**Racine Water and  
Wastewater Utilities**

SUBJECT: Change Order No. 3 – Contract W-19-18– STH 20 Pumping Station Improvements

Date of Issuance: December 9, 2020	Effective Date: December 9, 2020
Contract: STH Pumping Station Improvements	Owner: Racine Water and Wastewater Utilities
Contractor: Staab Construction Corp.	Owner's Contract No.: W-19-18
Address: 1800 Laemle Avenue	Engineer: Ruekert & Mielke, Inc.
Marshfield, WI 54499	Engineer's Project No.: 8022-10038.301
	Effective Date of Contract: September 5, 2019

PROJECT: RACINE STH 20 BOOSTER  
 (4.00) DIMENSION 400-400, MECH  
 (4.10) STRUCTURE 1  
 (4.13) SECTION VIEWS  
 SHEET TITLE: STH 20 PIPING MODS  
 SHEET NO.: PM1

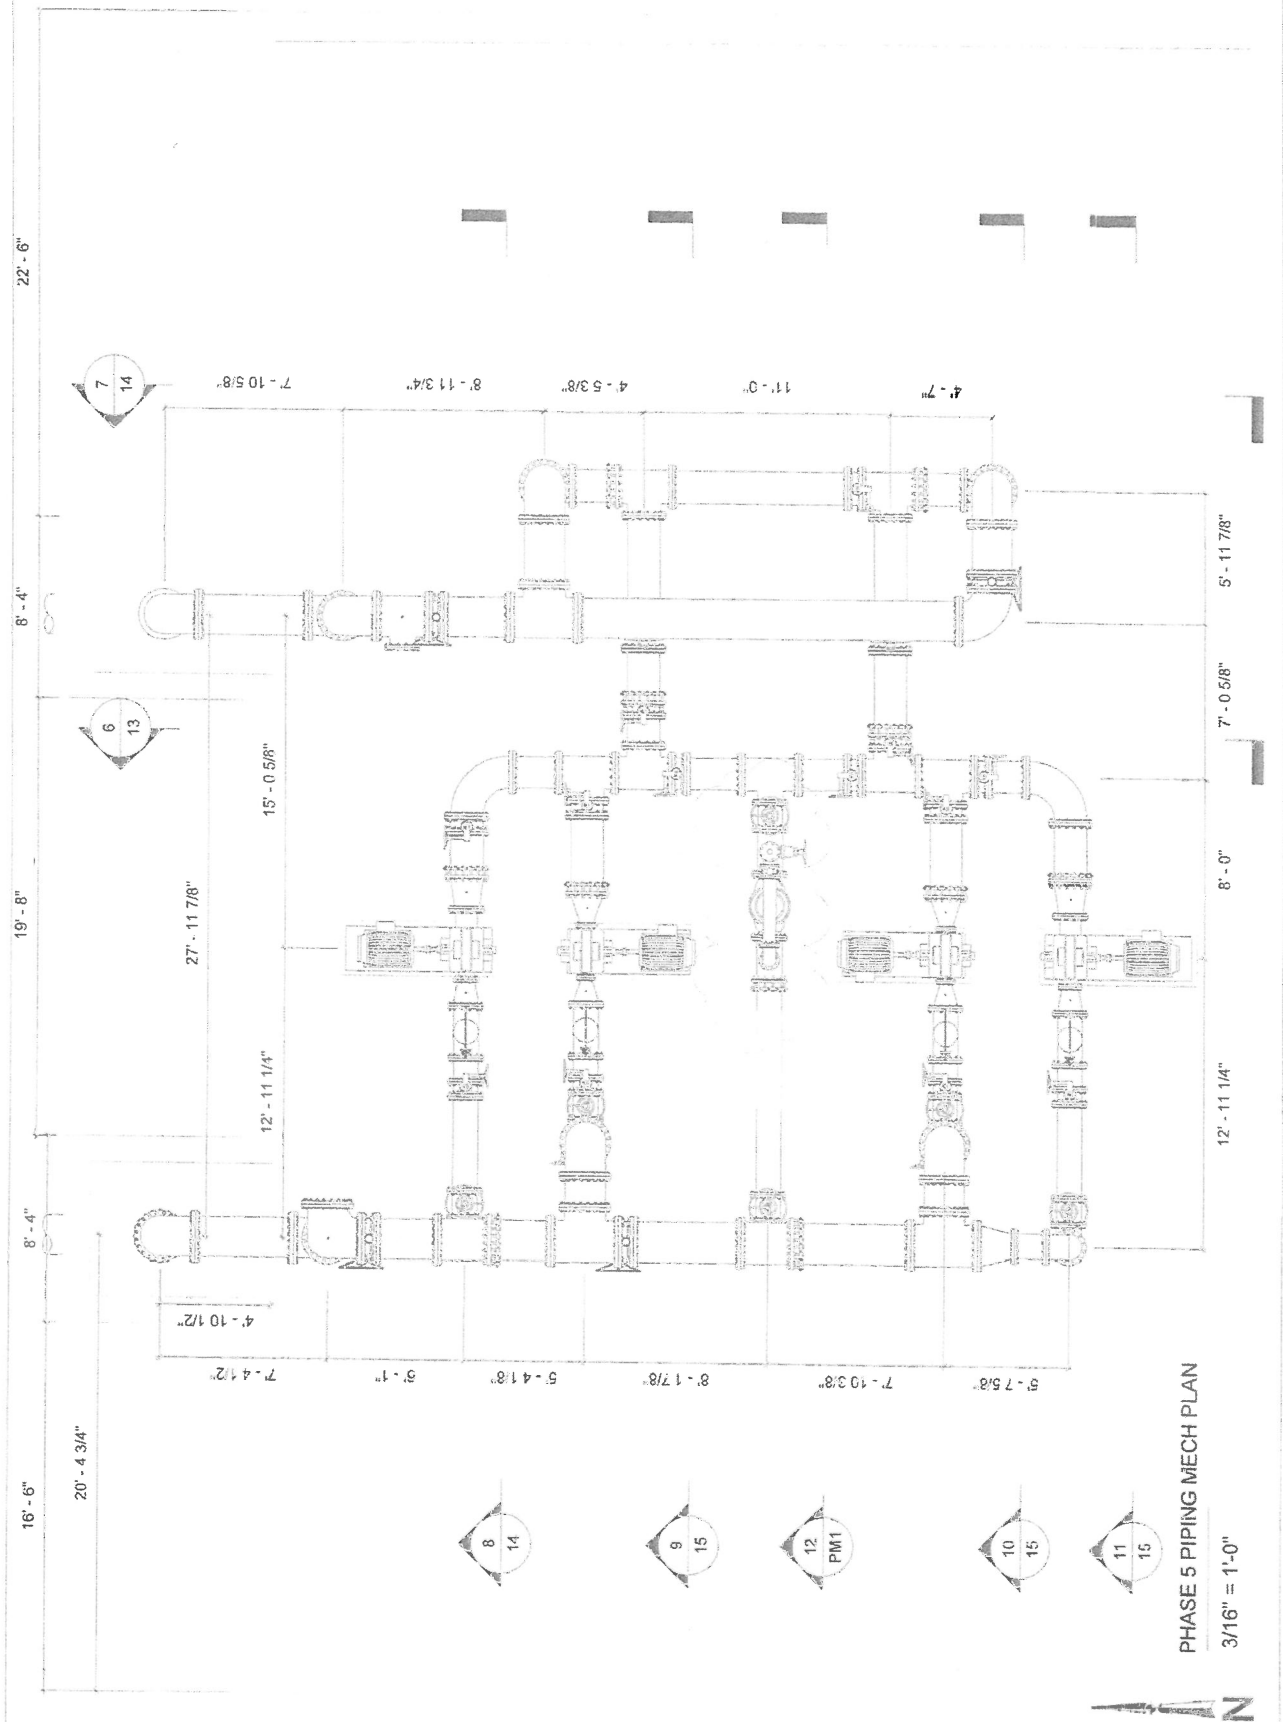
- 1) Complete interzone transfer piping within STH 20 Pumping Station. The work includes providing all 6-inch diameter piping, fittings, and valves and all 12-inch diameter piping modifications shown on the attached sketch, thus an add of \$10,246.00.
- 2) Remobilize and complete dual 20-inch water main connections north of the STH 20 Pumping Station, thus an add of \$32,014.00

- 1) The change is to provide a way to return water from the 933 Pressure Zone to the 875 Pressure Zone to reduce water age.
- 2) The dual 20" pipe stub installations (by others) was expected to be installed ahead of work on this Contract. This work (by others) was recently completed necessitating the Contractor's remobilization to the site to complete this work.

I have a favor to ask. Could you provide a quick budgetary cost for performing the following piping modifications (furnish and install) at Racine's STH 20 Pumping Station. The cost just needs to be in the ballpark in order to help us decide if we want to proceed with the work and would be performed outside of the existing contact. Please let me know if you have any questions.
